SECTION 14: TRAILS

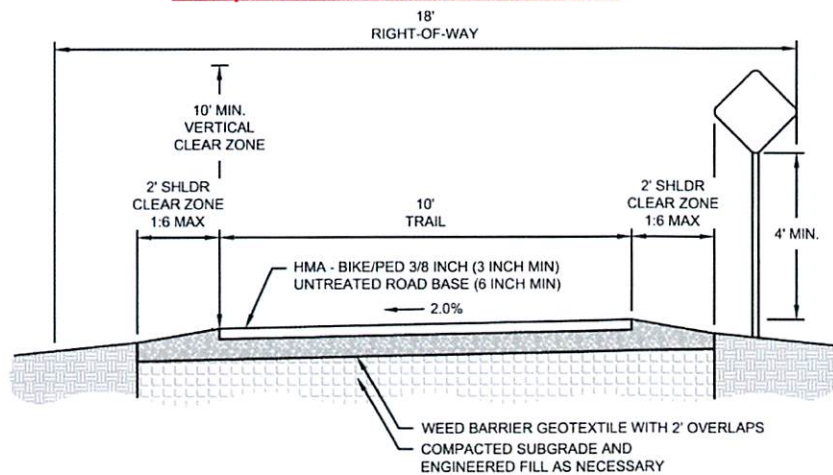
- ii. A minimum horizontal separation of ~~five feet (5')~~six feet (6') between the trail edge of pavement and roadway edge of pavement is required. Ideally,
